**SUBJECT: THREE MILE ISLAND, UNIT 1 (TMI UNIT 1)
OPERATING LICENSE NO. DPR-50
DOCKET NO. 50-289
LICENSE AMENDMENT REQUEST NO. 308, TRANSMITTAL OF
CAMERA-READY TECHNICAL SPECIFICATION PAGES**

**Operating License No. DPR-50
Docket No. 50-289
License Amendment Request No. 308
Transmittal of Camera-Ready Technical Specification Pages**

TMI Unit 1 Technical Specification Revised Pages for

(Pages ii, vii, 3-3, 3-4, 3-5, 3-5a, 3-5b, 3-18d, 3-18e, 3-18f, and 4-41)

Figure 3.1-1 Reactor Coolant System Heatup/Cooldown Limitations [Applicable through 29 EFY]

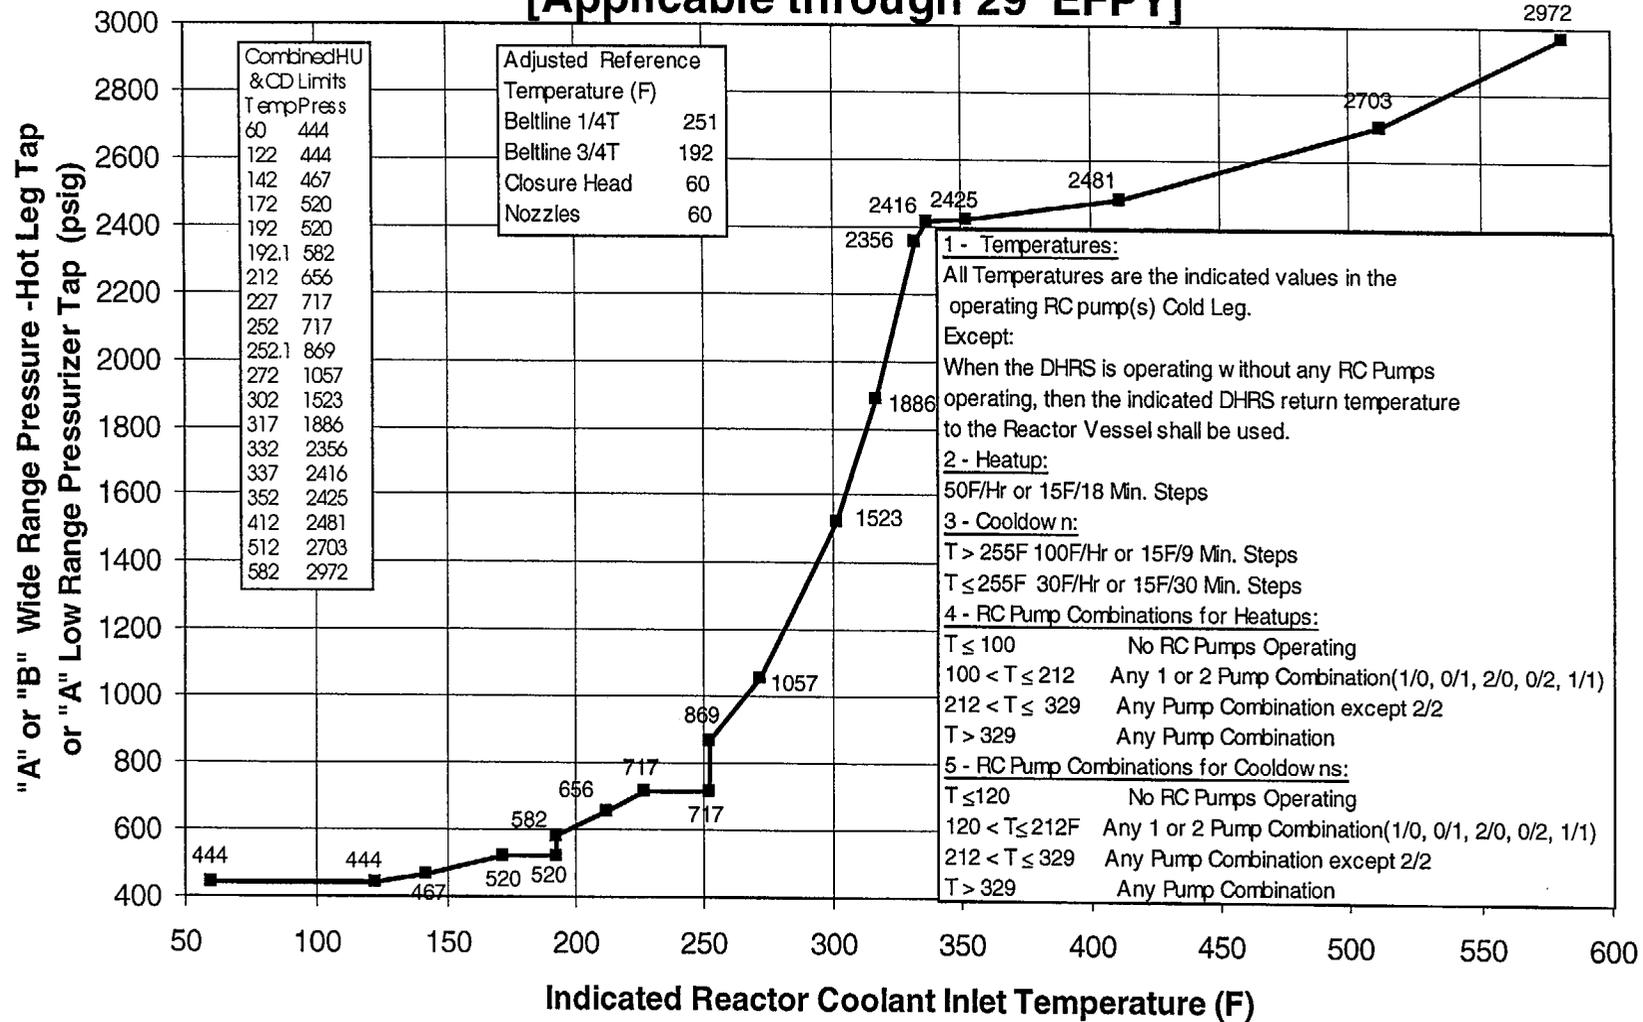
- 3.1.2.1 For operations until 29 effective full power years, the reactor coolant pressure and the system heatup and cooldown rates (with the exception of the pressurizer) shall be limited in accordance with Figure 3.1-1 and Figure 3.1-2 and are as follows:

Allowable combinations of pressure and temperature shall be to the right of and below the limit line in Figure 3.1-1. Heatup and cooldown rates shall not exceed those shown on Figure 3.1-1.

Figure 3.1-2 Reactor Coolant Inservice Leak Hydrostatic Test [Applicable through 29 EFPY]

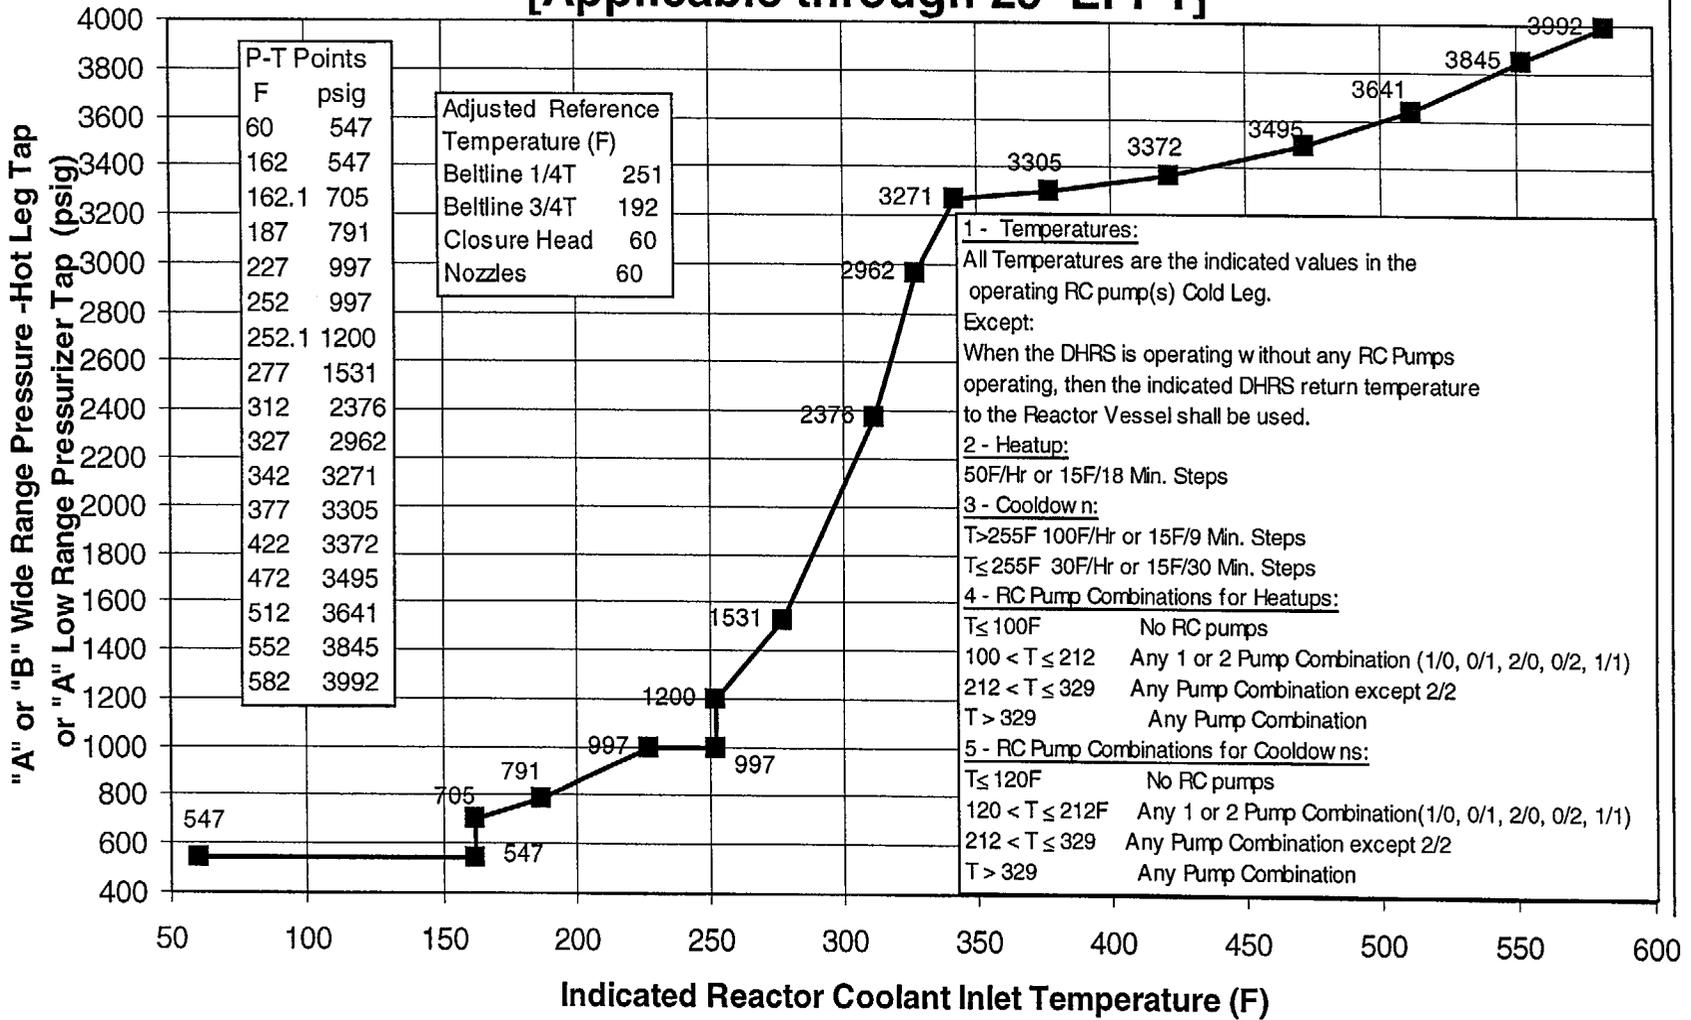
Allowable combinations of pressure and temperature shall be to the right of and below the limit line in Figure 3.1-2. Heatup and cooldown rates shall not exceed those shown on Figure 3.1-2.
